To	Cindy Luxhoj, City of Wilsonville
From	Jennifer Arnold, Emerio Design
CC:	Amy Pepper, City of Wilsonville
Date	October 17, 2023
Subject	DB23-0012 Canyon Creek South Site Design Review of Tract A – Incompleteness Letter Response

Items listed in the October 5, 2023, incompleteness letter will appear in *italics*, followed by the applicant’s responses in regular typeface.

**TRACT 'A' PATH & ADA
 RAMP GRADING PLAN &
 PROFILE**

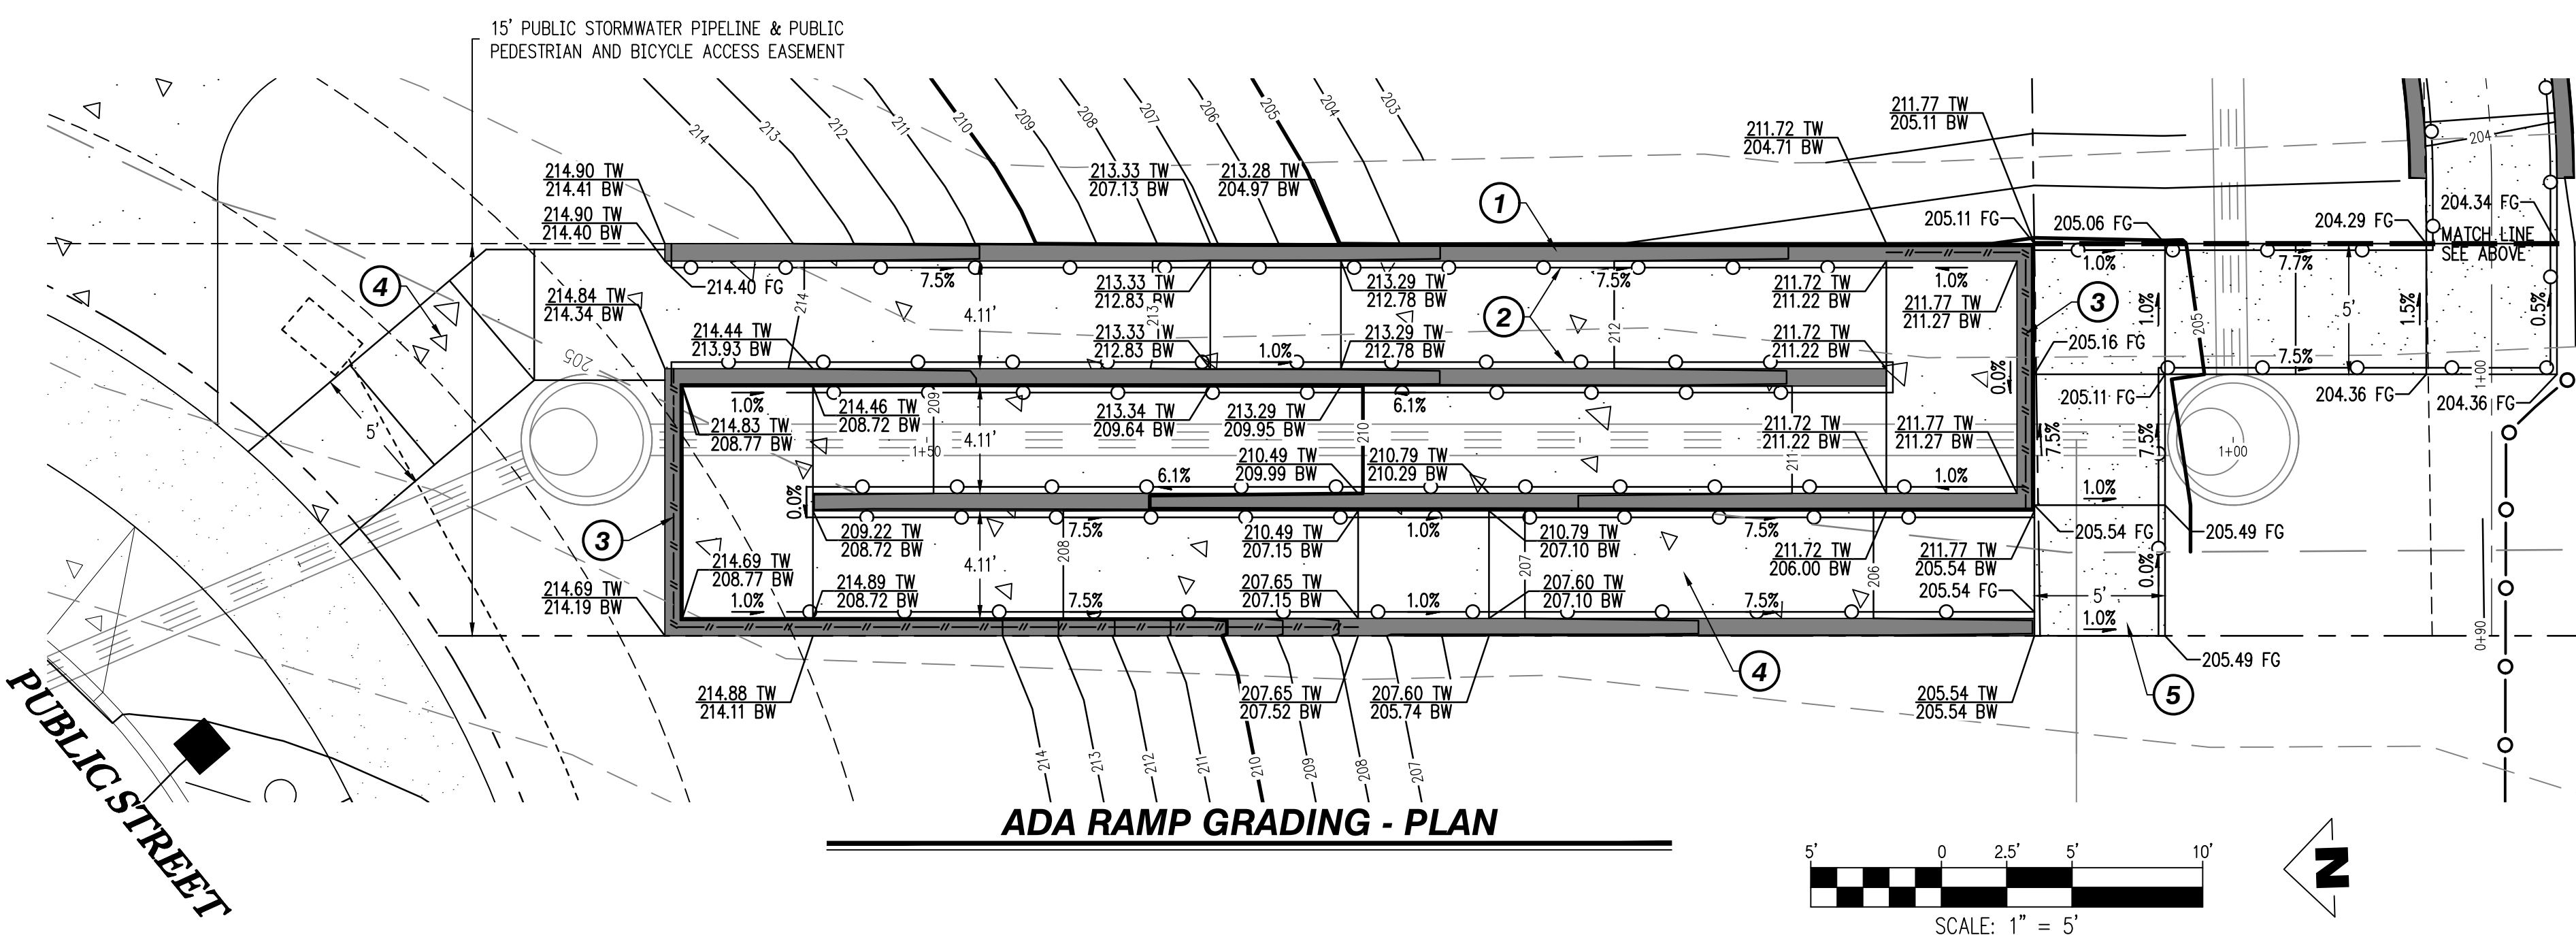
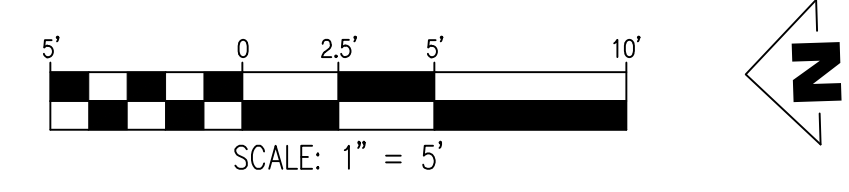
1. *Indication of how the concrete walk in the Tract A open space connects to the sidewalk in the public right-of-way. The pathway must be vertically or horizontally separated from the driveway in accordance with WC Section 4.154. The pathway must be ADA compliant. Submit a grading plan showing that the ADA pathway can be constructed as shown.*

Applicant Response: As included in Exhibit A, a grading plan showing pathway grades to demonstrate compliance with ADA standards. The driveway previously proposed at the public street has been changed to a 5 foot wide sidewalk that continues to Tract A.

Figure 5: Sidewalk Detail—Exposed Aggregate Concrete
Interagency Initiative for National Mall Road Improvement

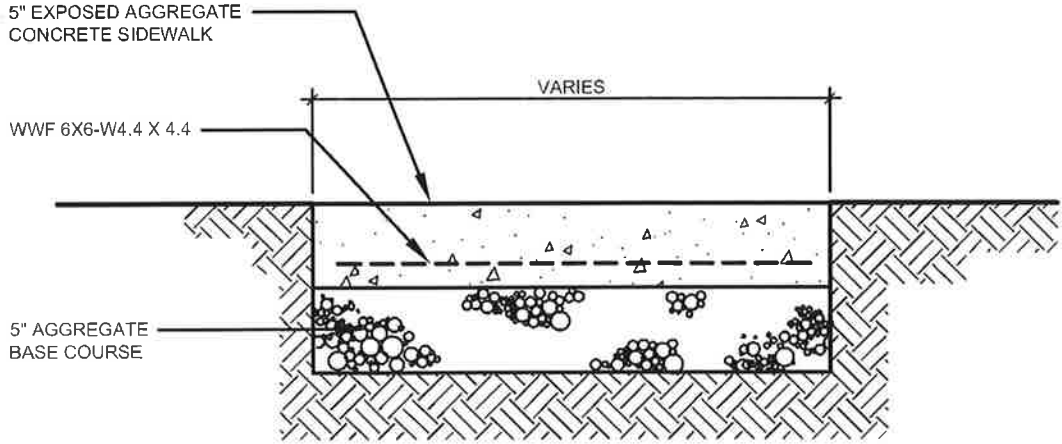
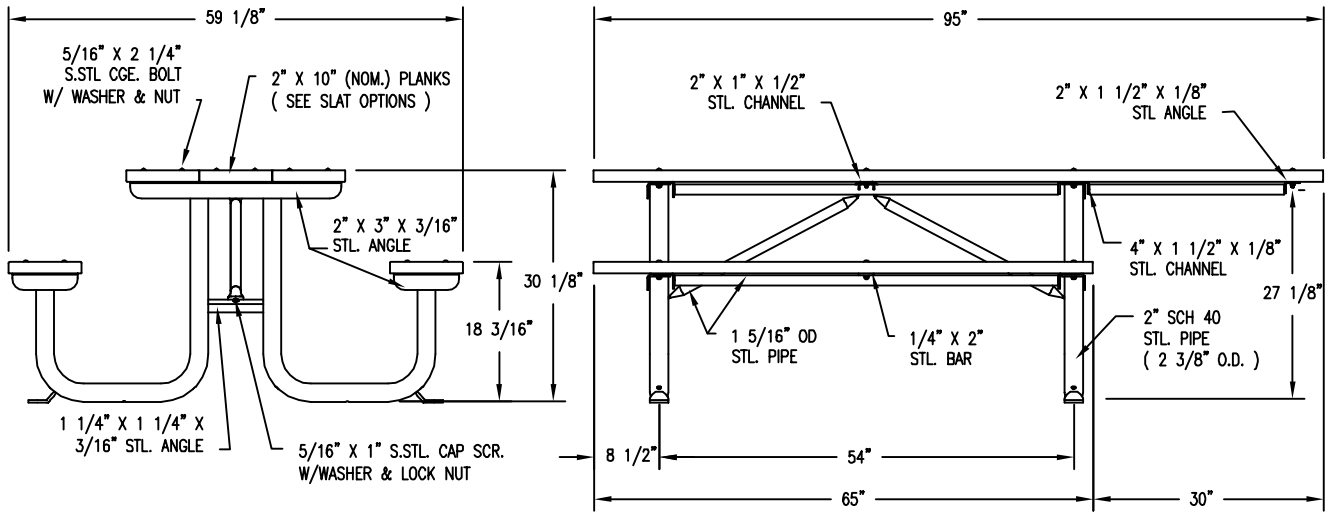
2. *Materials detail or cut sheet describing the surface treatment (“exposed pea-gravel aggregate finish”) of the concrete walk.*

Applicant Response: A detail of the exposed aggregate concrete sidewalk has been included as Exhibit B to address this comment.

PICNIC TABLE	DATE DRAWN : 03/22/94	REV. J	DRAWING NUMBER 77-68-1PL	SHEET 1 OF 2
		DRAWN BY : CDC			
		DATE REV. : 01/11/17			
		REV. BY : RDH

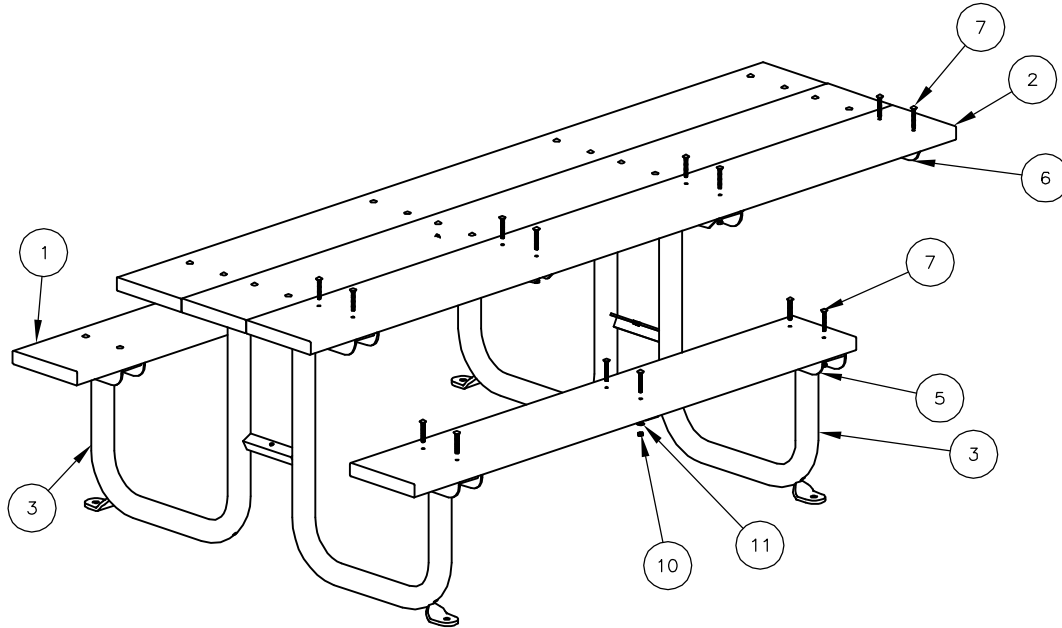
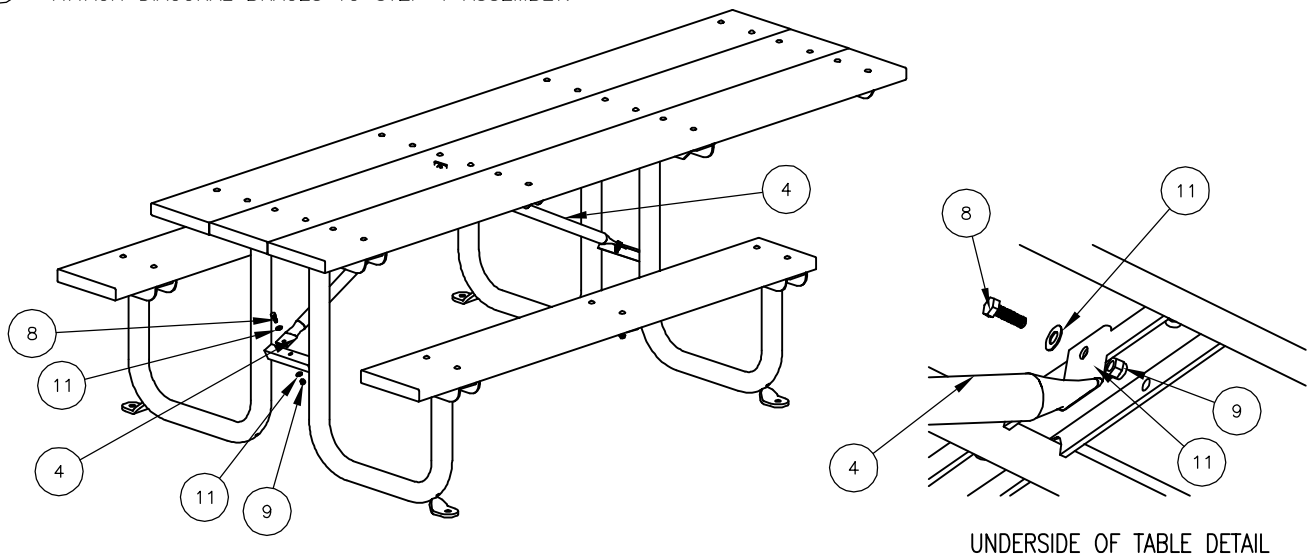
3. *Materials detail or cut sheet of the benches, picnic table, and any other site furnishings.*

Applicant Response: Included with Exhibit C are example images and detail sheets for both the picnic table and the benches. The example picnic table is intended to demonstrate material colors and materials but is not an ADA table as the detail specifies. The applicant proposes an ADA picnic table but had difficulty finding the appropriate image to match the detail.

Exhibit D: Preliminary Plat Showing SROZ Boundary

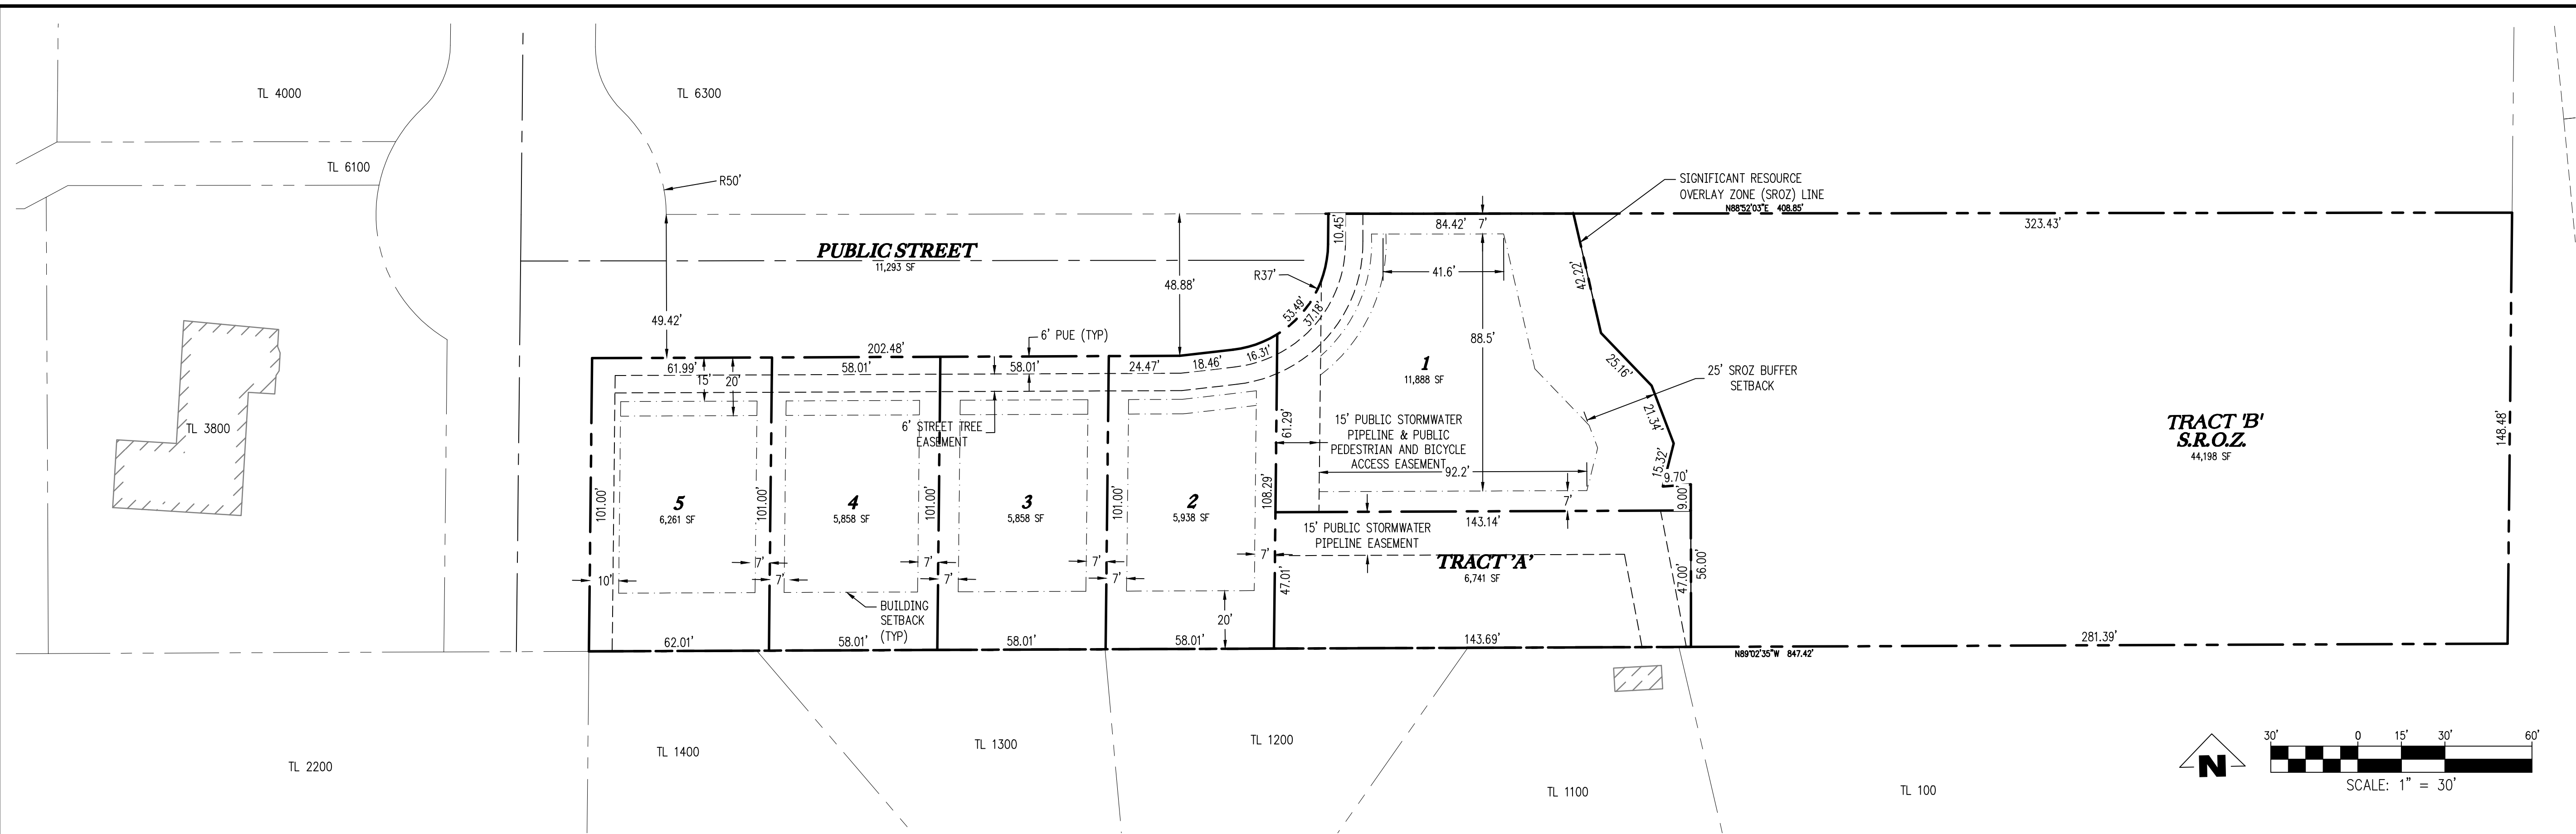
5. *Sufficient information indicating where the SROZ and Impact Area boundaries are in relation to the Tract A open space improvements, and demonstrating impacts to the SROZ and buffer zone, if applicable, and proposed impact mitigation. Demonstrate that only native plantings are proposed in the SROZ and Impact Area, if any, in the Tract A open space.*

Applicant Response: The eastern boundary of Tract A is the SROZ boundary, but this overlay has an associated 25 foot buffer which projects into Tract A. Within the 25 foot buffer from the eastern boundary, the applicant proposes to plant one new tree (Western Dogwood native cultivar) and a mix of several native cultivar shrubs and perennial grasses. See the submitted landscape plan for plant details. No structures, walls, impervious surfaces, or disturbances are proposed within the SROZ buffer area and certainly not in the SROZ protection Tract approved with the subdivision approval. Invasive plants within Tract A such as Himalayan blackberry are proposed to be removed and replaced with non-invasive plant materials.
